1040-1050 7th Ave SW, Albany, OR 97321

**7th St. Due Diligence  
Opinion of Cost  
May 19th, 2024**

Community Development  
Building and Planning  
City of Albany  
333 Broadalbin Street SW  
Albany, Oregon 97321-0144

See plan exhibits for the extent of demolition and interior renovation. No additions are planned. The proceeding section of this letter lists the questions Varitone Architecture has for the City's pre-application review.

ITEM #5: EXISTING DOOR IN QUESTION

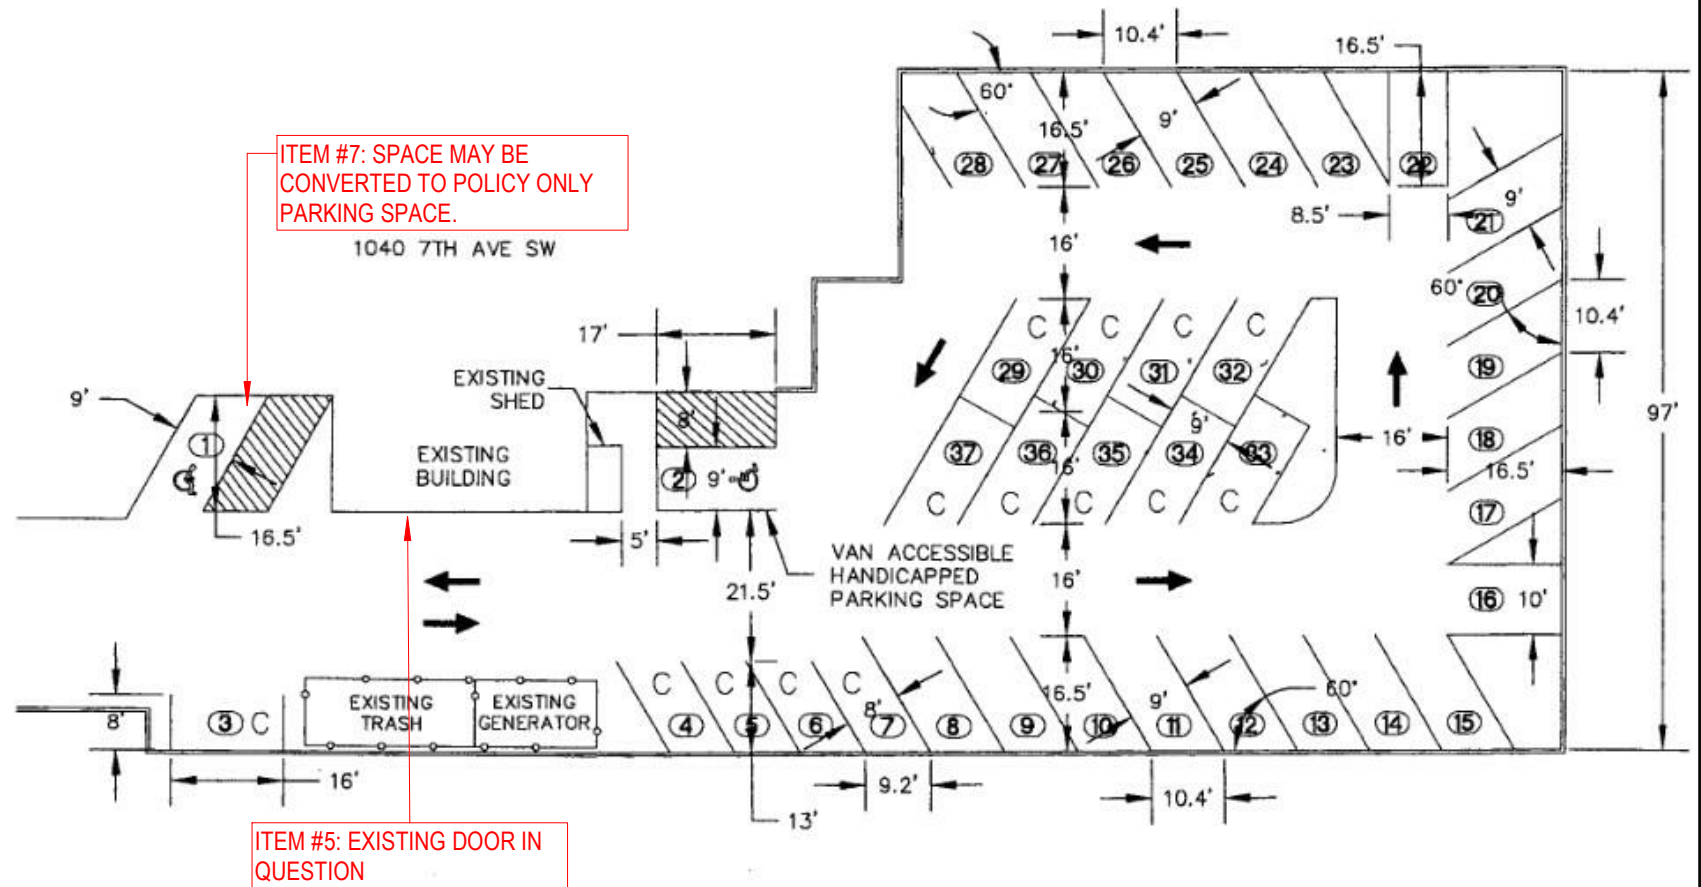
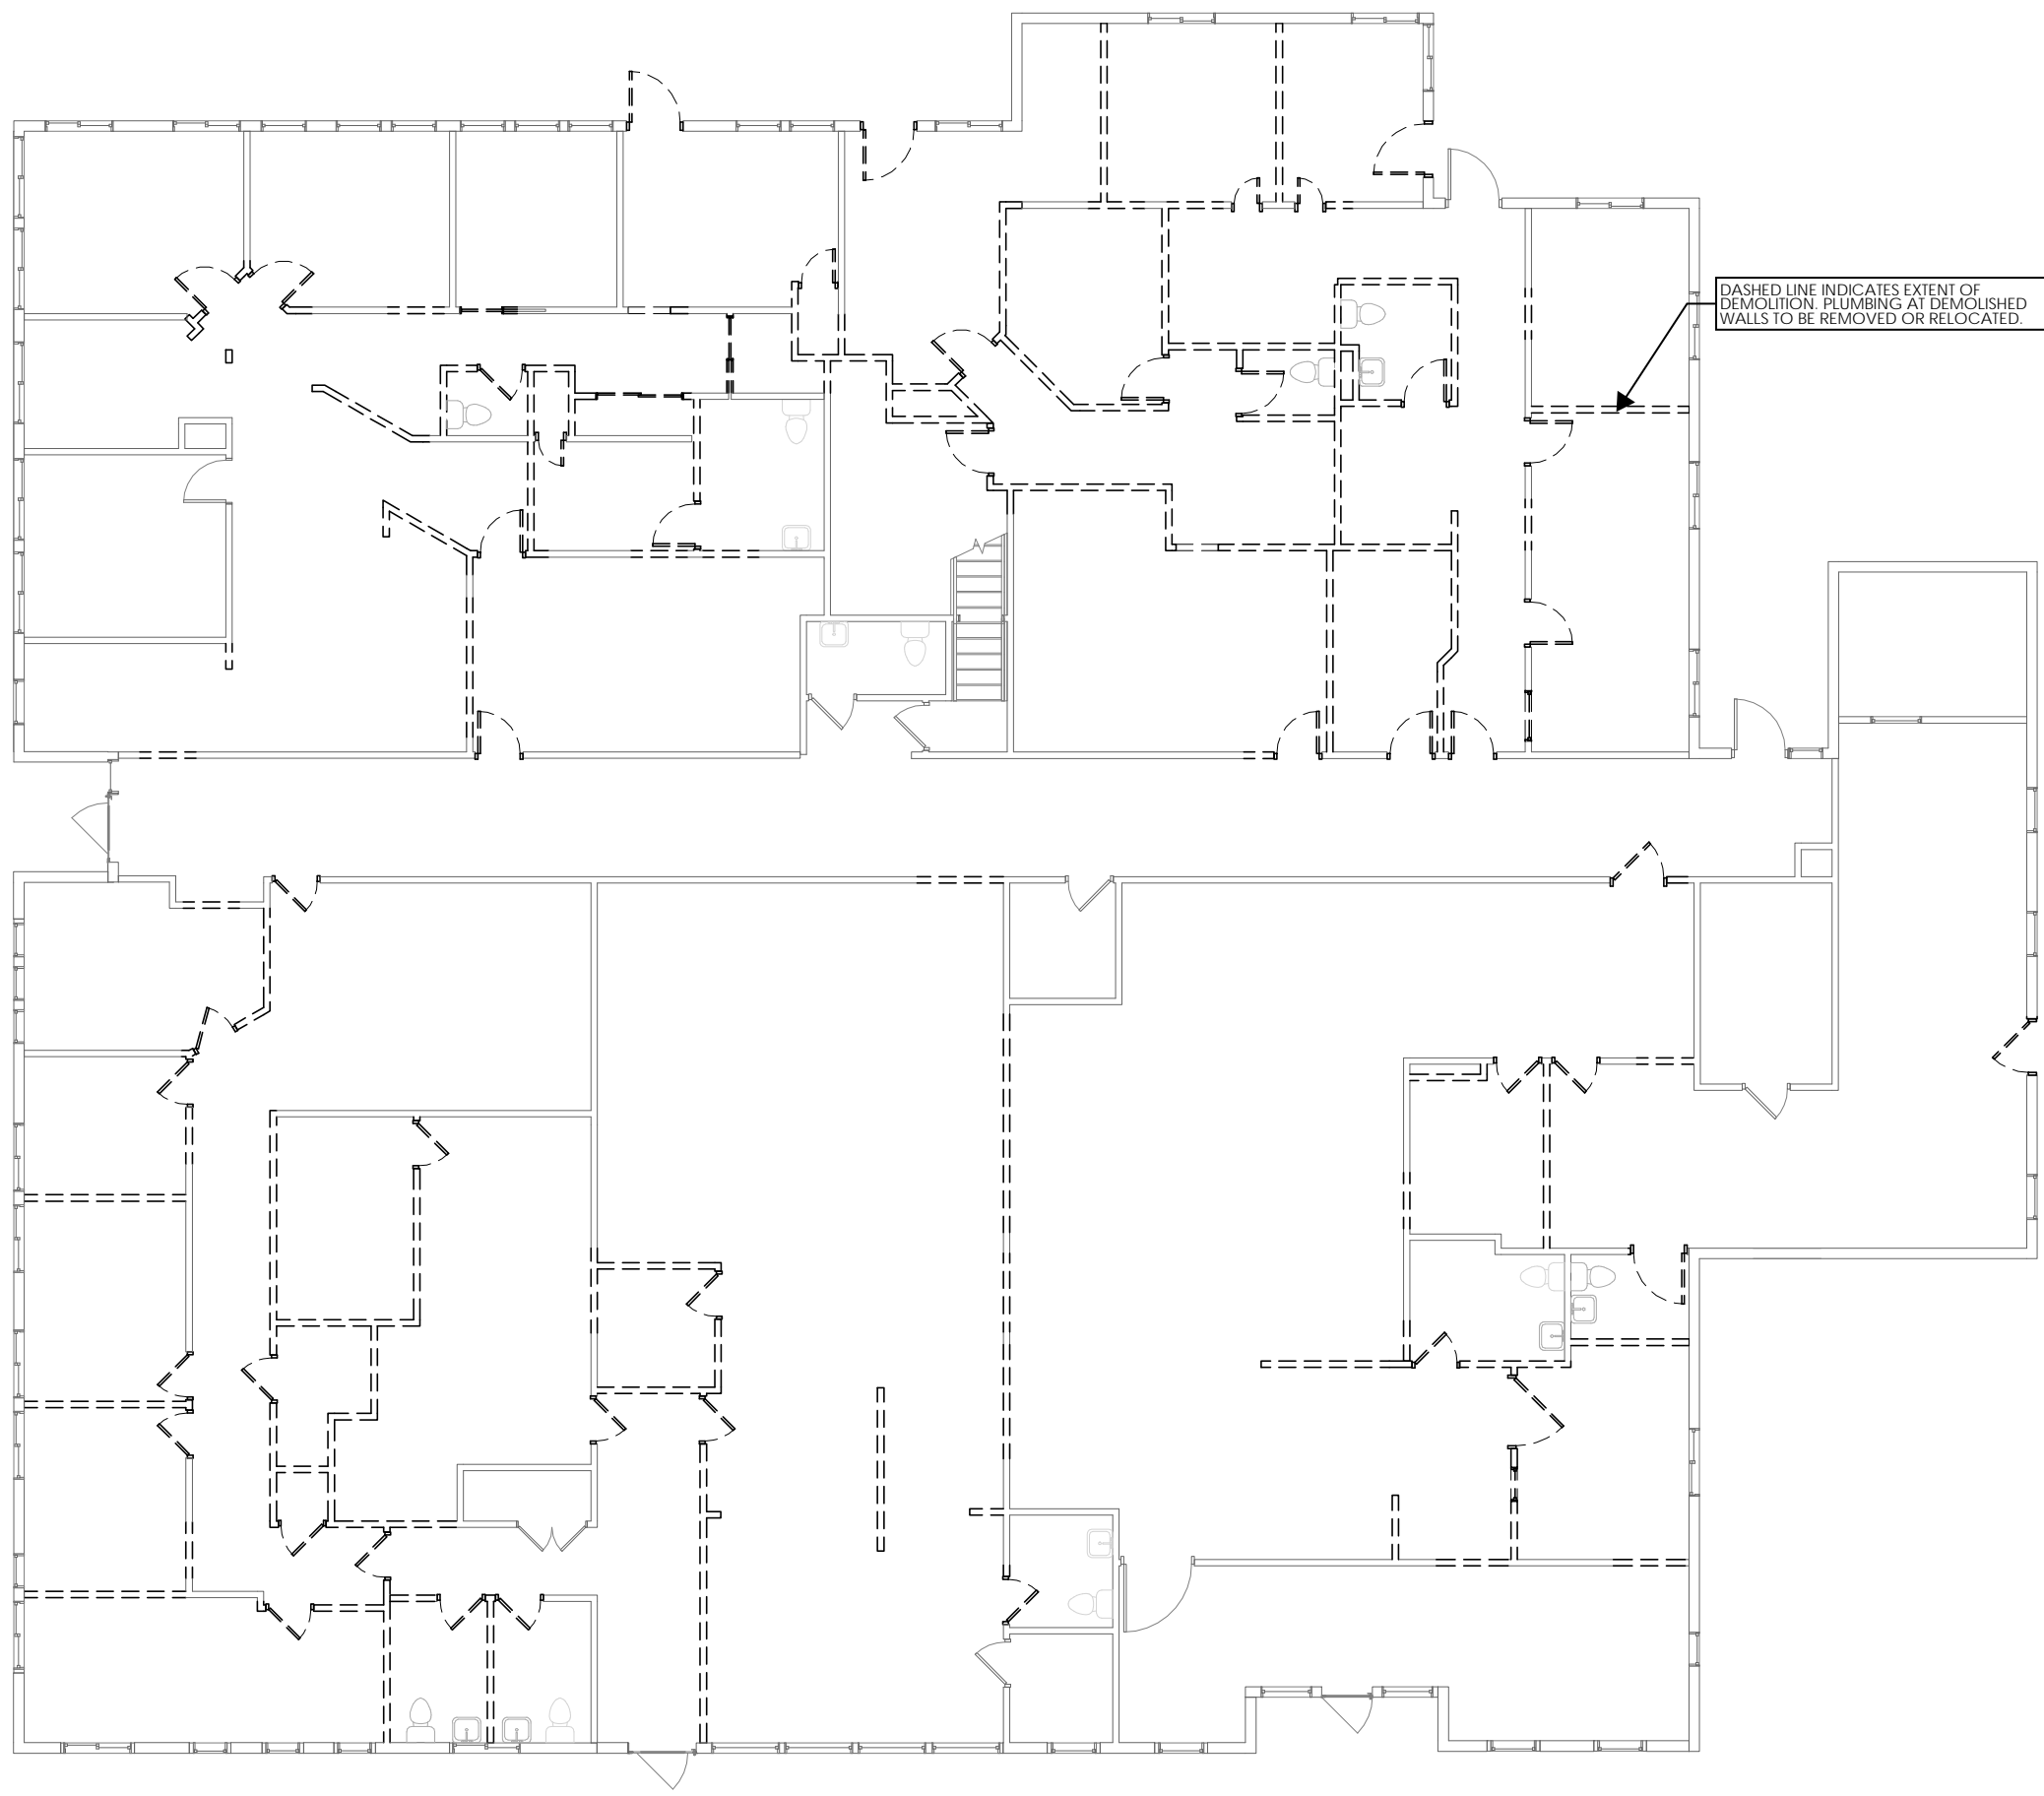
4. Please confirm that existing parking quantities will not be required to be modified for any reason.
5. There is an existing exit door that leads out to the driveway off of 7<sup>th</sup> Avenue. In the new floor plan, the client wishes to use this as a police entry, for when they bring persons in for intake. The existing driveway is 24' wide, not allowing for a separate walkway from this backdoor of the existing building. This door is existing, nonconforming. Will anything about this new design trigger an issue for that door exiting without an adjacent pedestrian walkway?

ITEM #6: NO PEDESTRIAN WALKWAY TO CITY SIDEWALK OR FROM BUILDING TO PARKING

ITEM #7: SPACE MAY BE CONVERTED TO POLICY ONLY PARKING SPACE.

**EXISTING PARKING LOT LAYOUT**

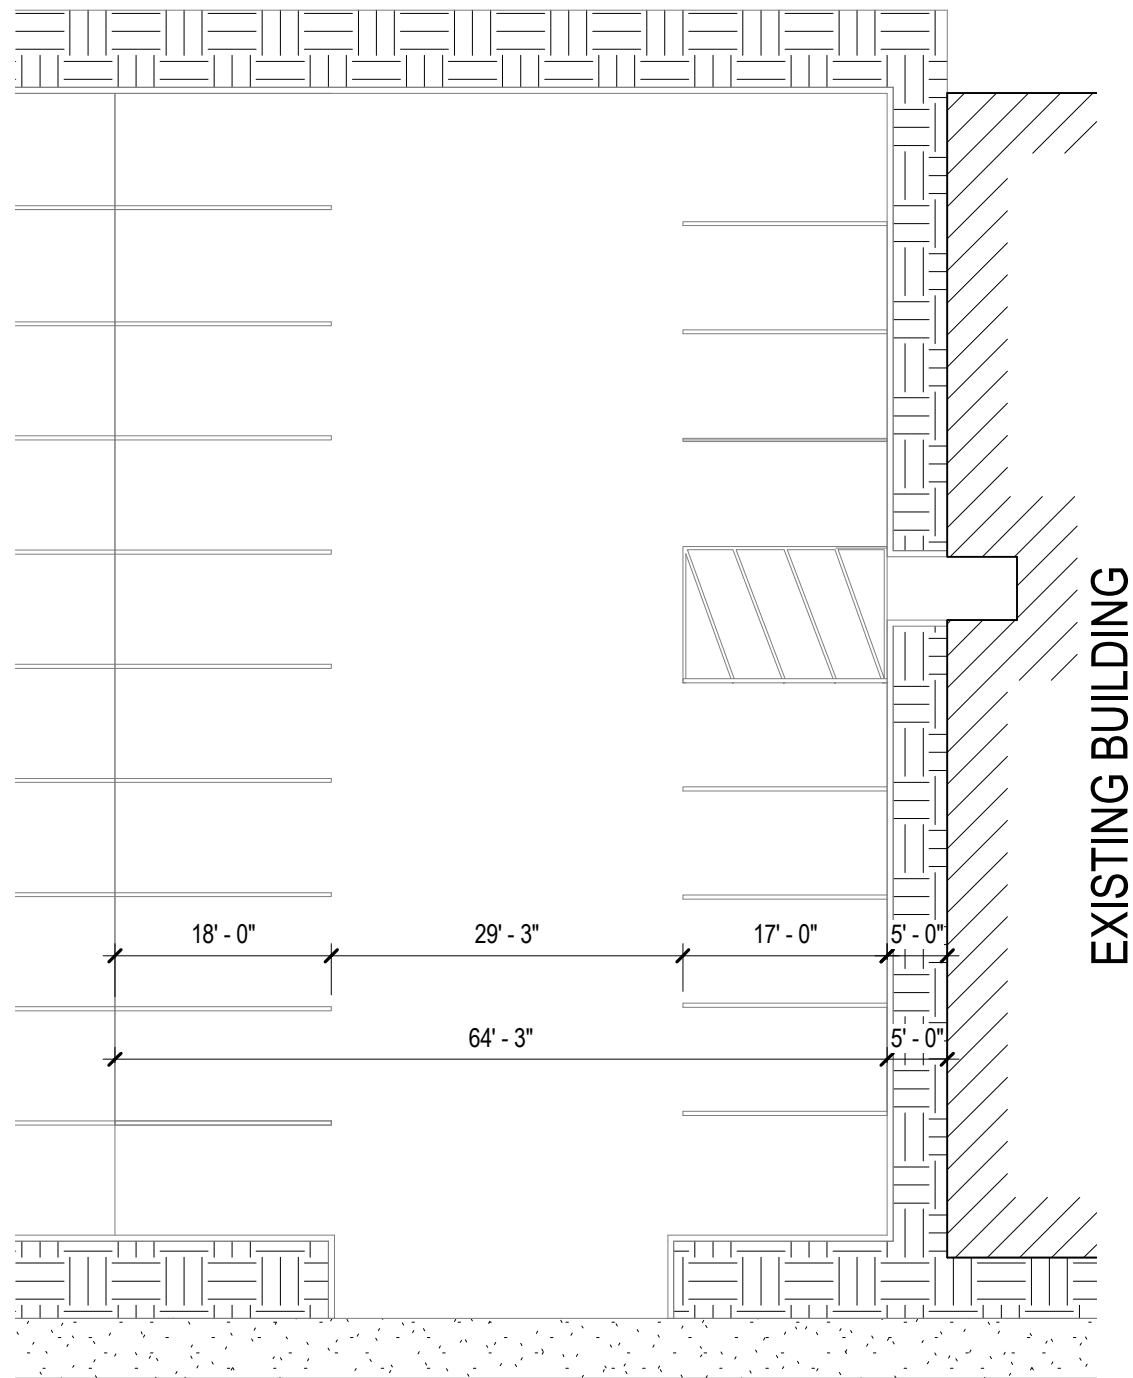
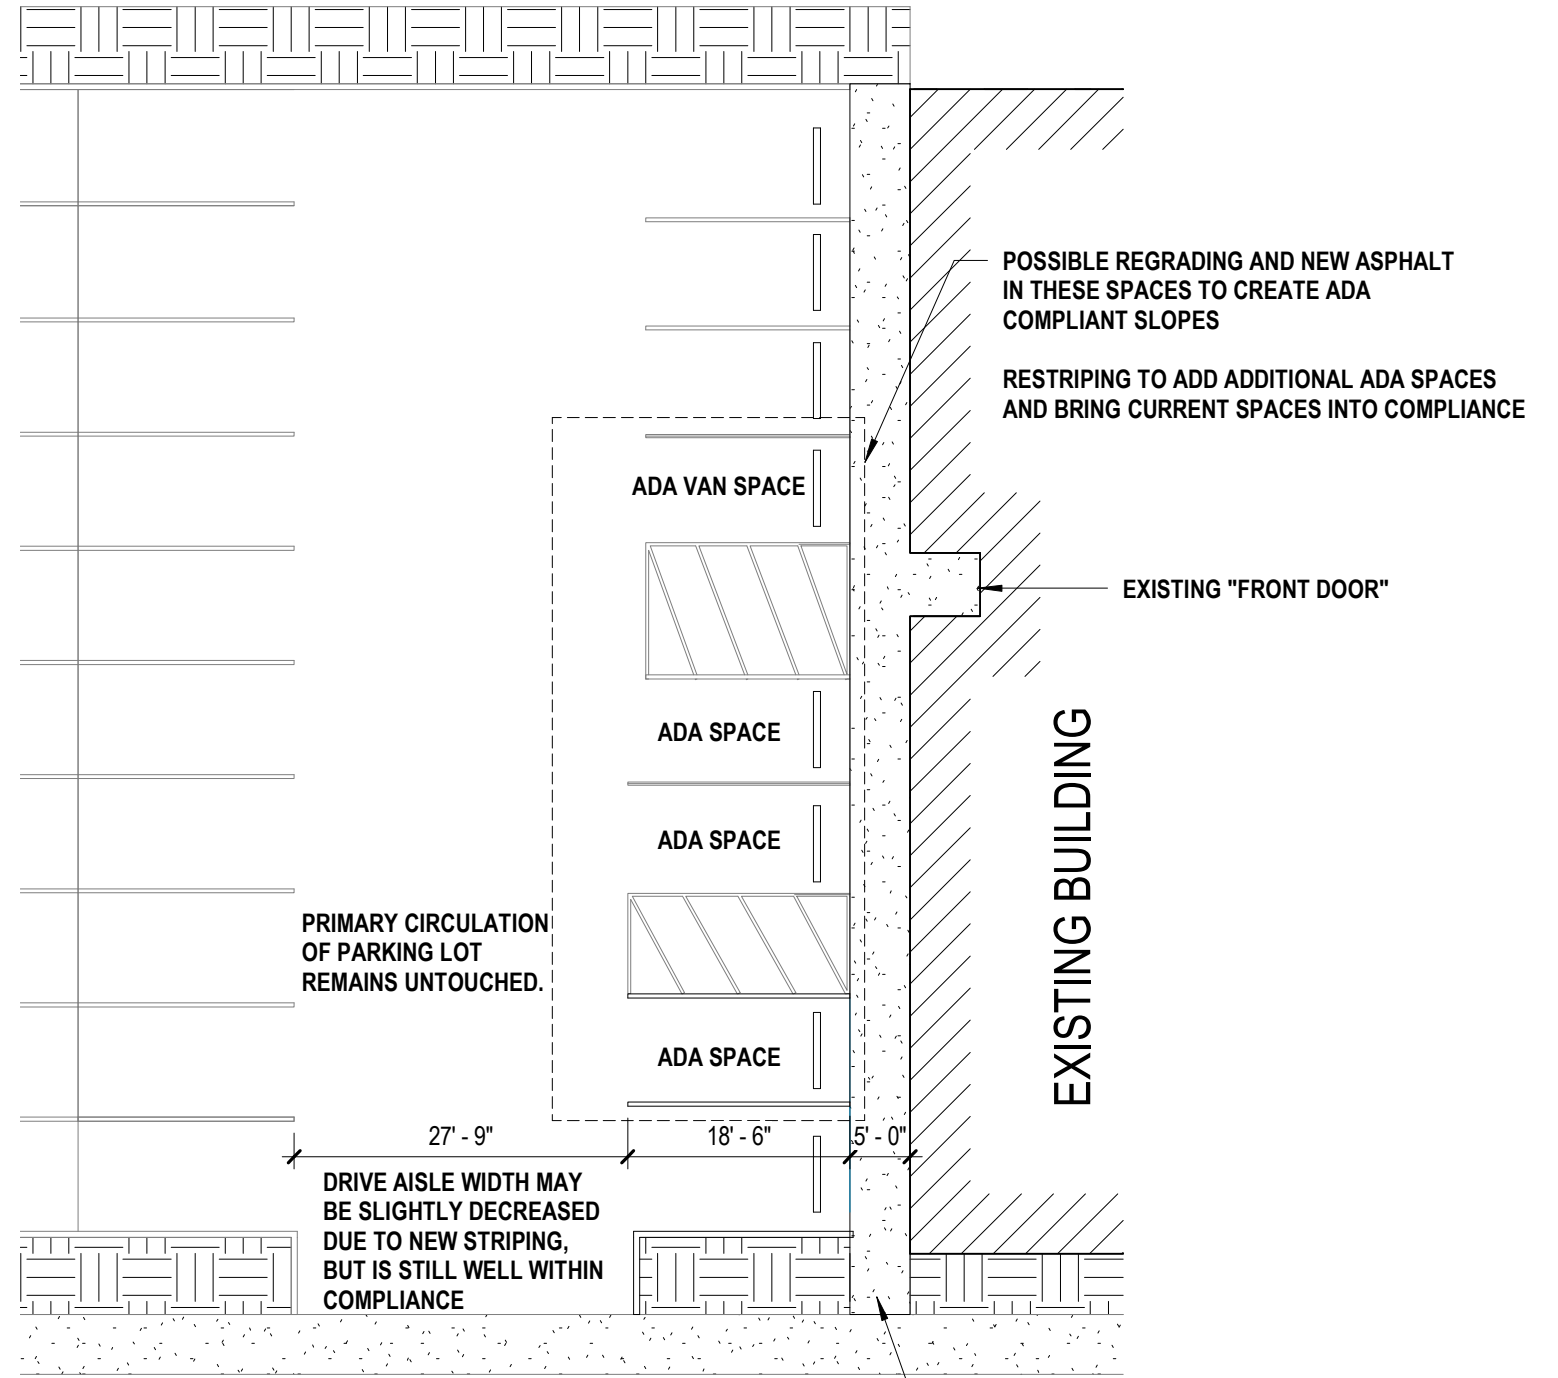
THIS AREA OF PARKING LOT: NEW STRIPING AND ASPHALT TO CREATE CORRECT ADA COMPLIANT SLOPES. NEW PEDESTRIAN CONNECTION ADDED. SEE NEXT SHEET.

SINCE THERE IS NOT A CHANGE IN PARKING LOT CIRCULATION OR OVERALL LAYOUT, WE DO NOT BELIEVE THIS TRIGGERS A SITE PLAN REVIEW OR OTHER PLANNING PROCESS. PLEASE CONFIRM.

See the attached pdf. We are proposing that we can add a sidewalk connection in the location of the existing planter strip along the front of the building. This would provide the ADA connection to the front door and from the ADA parking spaces. Then we'd restripe the spaces to put all of the required ADA spaces along this front side of the building, closest to what will be the public front door. The paving in this area will likely need to come out and get redone to accommodate correct ADA slopes.

HOWEVER, the main circulation and layout of the parking lot will not be affected by this change (see attached plans).

I don't believe this would trigger a site plan review? (New sidewalk between parking and building, and new ADA spots.) And if it doesn't trigger a site plan review, then it would not trigger Chapter 2 Non-conforming Sites. Please confirm.

Thanks for checking in about this. After checking with the other planners, even if the asphalt needs to be redone, we will not require the full parking lot to be brought up, nor would it be subject to a site plan review (unless one of the other triggers occurs). Now, there may be some building code requirements that are triggered, but not planning. Please let me know if you have any additional questions.
